SUBDIVISION REPORT -CONCEPT/USE ON REVIEW

AGENDA ITEM #: ► FILE #: 6-SD-22-C 32

SUBDIVISION: **ANDES HILL**

Requested Variances & Alternative Design Standards

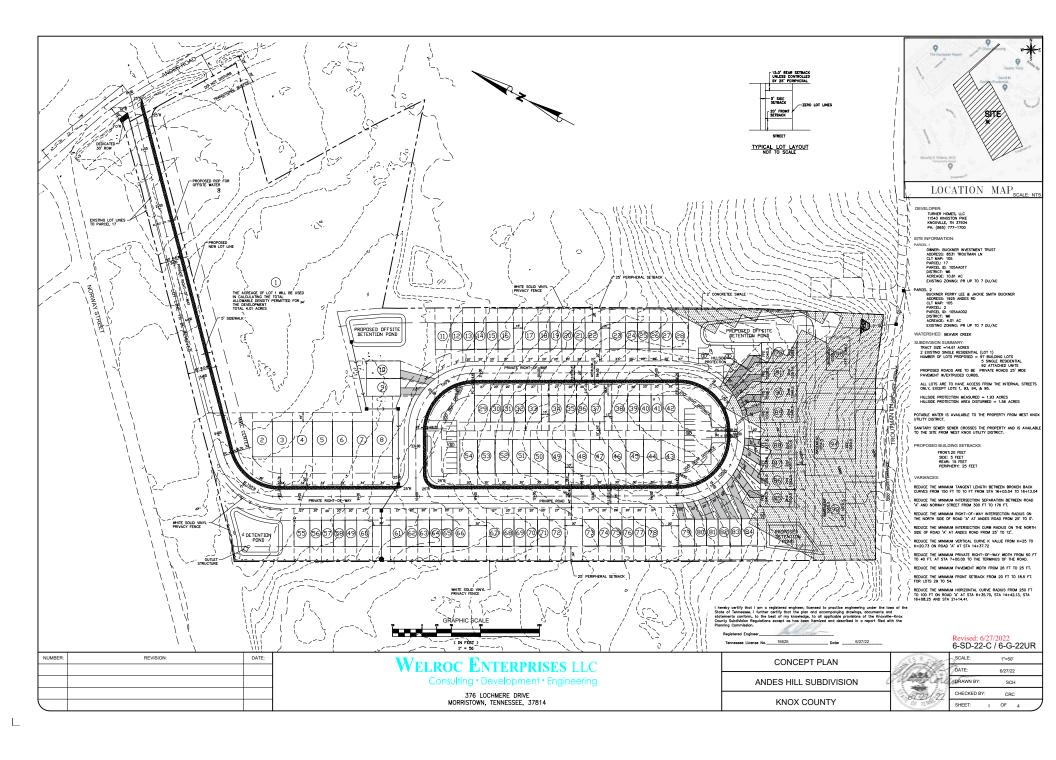
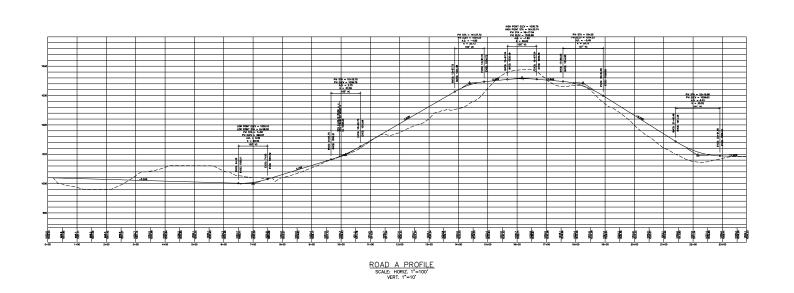
- 1. Reduce the minimum broken back tangent from 150' to 10' from STA 15+98.24 to 16+08.25
- Reduce the minimum intersection separation between Road 'A' and Norway Street from 300' to 176'
- 3. Reduce the minimum intersection right-of-way radius on the north side of Road 'A' at Andes Road from 25' to 0'
- 4. Reduce the minimum intersection curb radius on the north side of Road 'A' at Andes Road from 25' to 12'
- 5. Reduce the minimum vertical curve K value from K=25 to K=20.73 on Road 'A' at STA 13+87.72

- 1. Reduce the minimum private right-of-way width from 50' to 40' from STA 7+00 to the terminus of the road
- 2. Reduce the minimum pavement width from 26' to 25'
- 3. Reduce the minimum horizontal curve radius from 250' to 100' on Road 'A' at STA 6+35.70
- 4. Reduce the minimum horizontal curve radius from 250' to 100' on Road 'A' at STA 14+42.13
- Reduce the minimum horizontal curve radius from 250' to 100' on Road 'A' at STA 16+08.25
- 6. Reduce the minimum horizontal curve radius from 250' to 100' on Road 'A' at STA 21+14.41

Approve
SE 7/17/2022

ROAD PROFILE	300
ANDES HILL SUBDIVISION	
KNOX COUNTY	, WW.

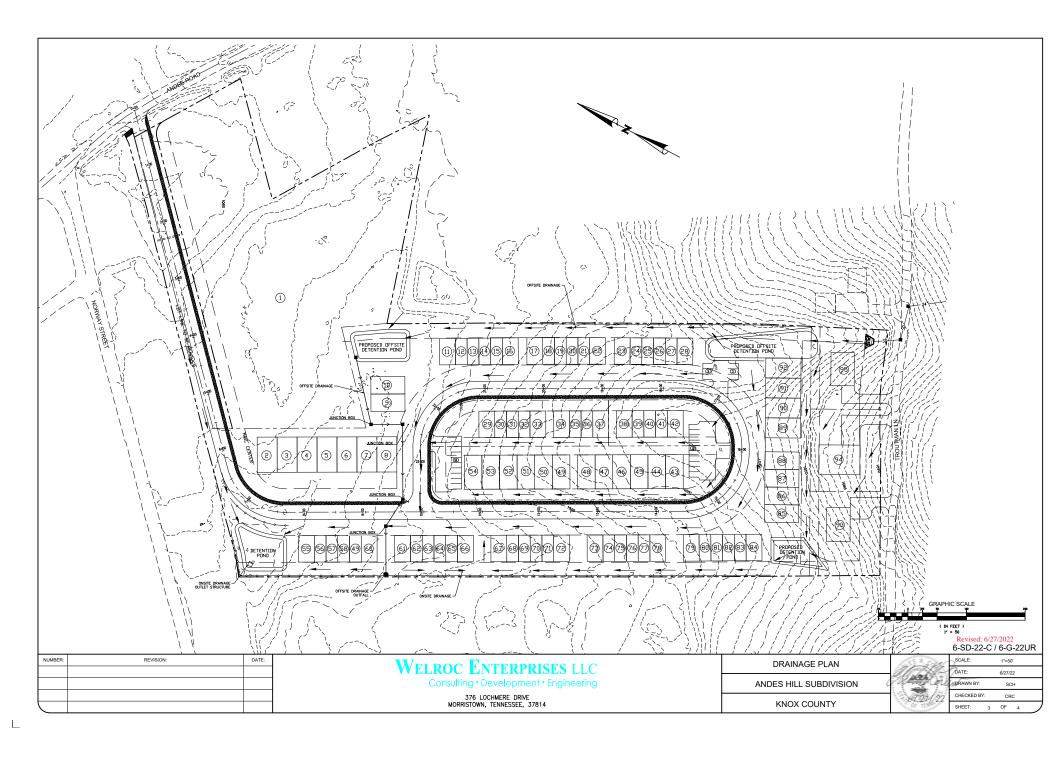
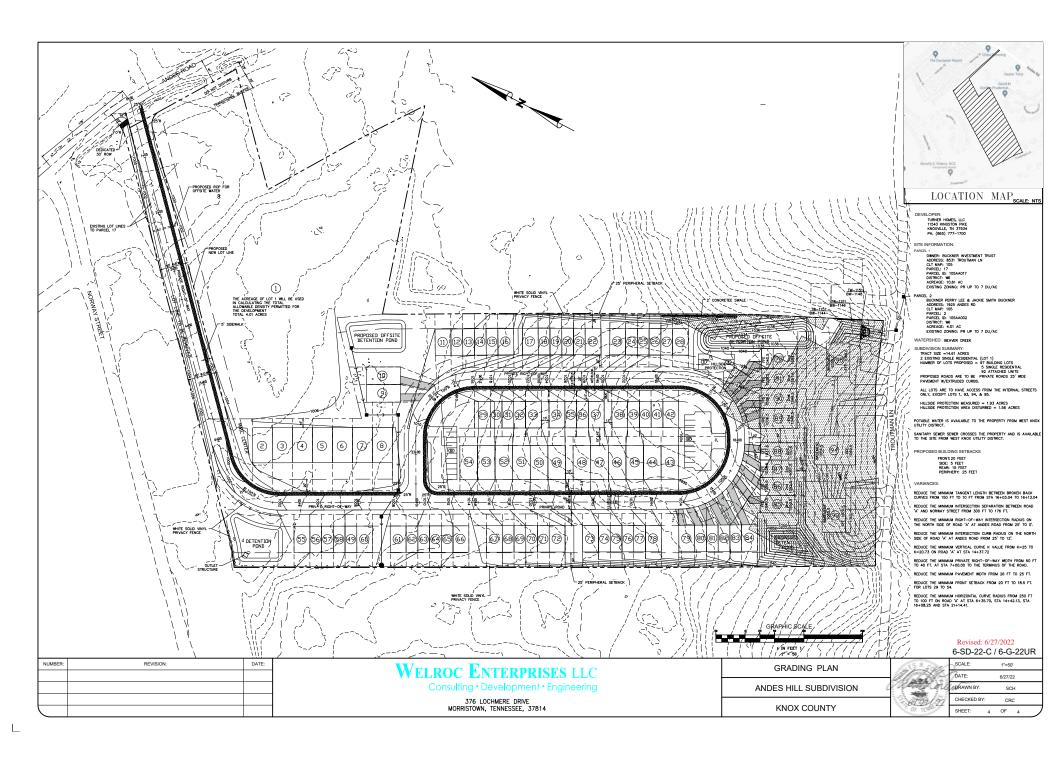
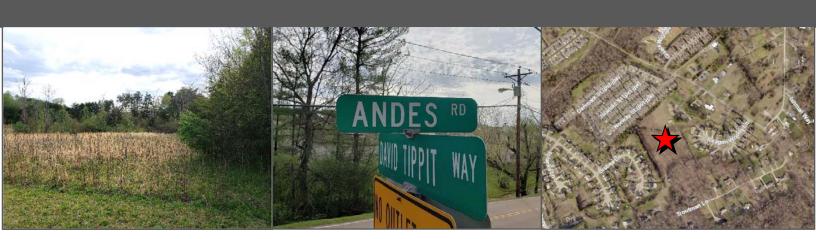
- 8) Revising the road profile to obtain a minimum 1 percent grade, with review and approval by Knox County Engineering and Public Works during the design plan phase.
